Access Compliance Report Public Rights-of-Way (Curb Ramps)

Main Street: N/A Cross Street: ANTONIO_PKWY Location: SW

ADA ID: RPRK220223135536 Ramp Type: Type 1 - Perpendicular Initial Pass/Fail: Pass Overall Compliance: No Severity Score: 15

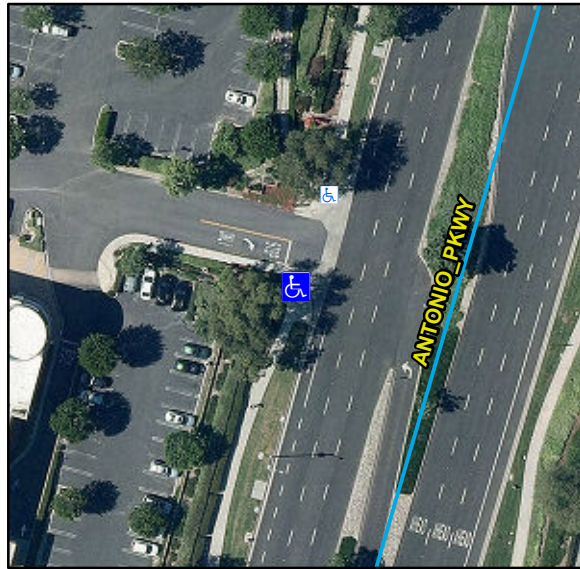
R304.2.1, R305, R304.5.4, STD 1115

N/A	Ramp Inside Crosswalk 1	N/A	Yes	Ramp Inside Crosswalk 2	N/A
	Crossing 1 Slope (%)	2		Crossing 2 Slope (%)	2.7
	Crossing 1 Cross Slope (%)	1.3		Crossing 2 Cross Slope (%)	4.2
Yes	Gutter Ponding	No	Yes	Curb Slope	2.3
Yes	Gutter Lip Height (in)	0		Road Run Slope (%)	0.7
No	Gutter Run Slope (%)	9.9		Road Cross Slope (%)	3.8
Yes	Gutter Cross Slope (%)	1.7			
Yes	Overall Surface Condition: Acceptable		Yes	Perp Joint Present	Yes
	Cross Gutter Present?	Yes		Spandrel Present?	Yes
	Replace Cross Gutter?	No		Replace Spandrel?	No

Remove & Replace Entire Ramp. Remove & Replace Gutter.
